SERVICE - INFO

STEYR – 230 0022 11 – 280/295 TGU6**

TBI_sdf230002211

New design / Neues design / Nouvelle conception / Nuovo design / Nuevo diseño

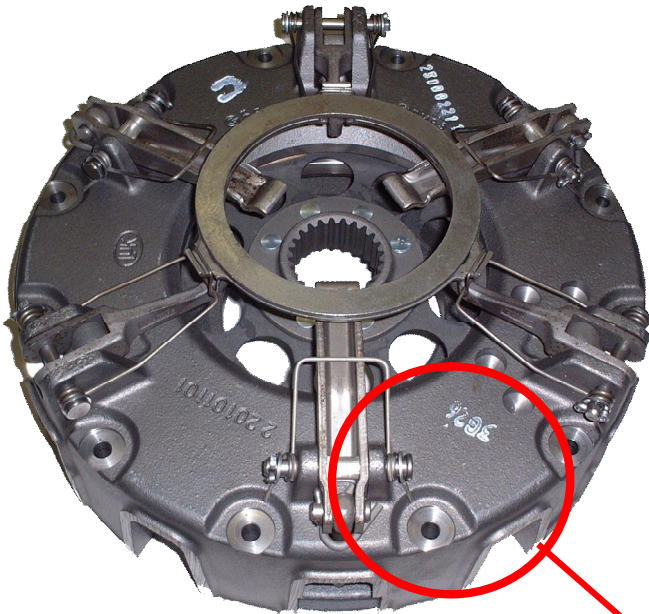
The new design utilises the latest clutch technology using a vented housing for improved cooling and heat dispersal.

**Fully interchangeable with existing clutches with no modifications required to vehicle or flywheel.
New fixation bolt set 6 x M8 x 1.25 x 50mm is supplied with new designs to accommodate the lower housing.**
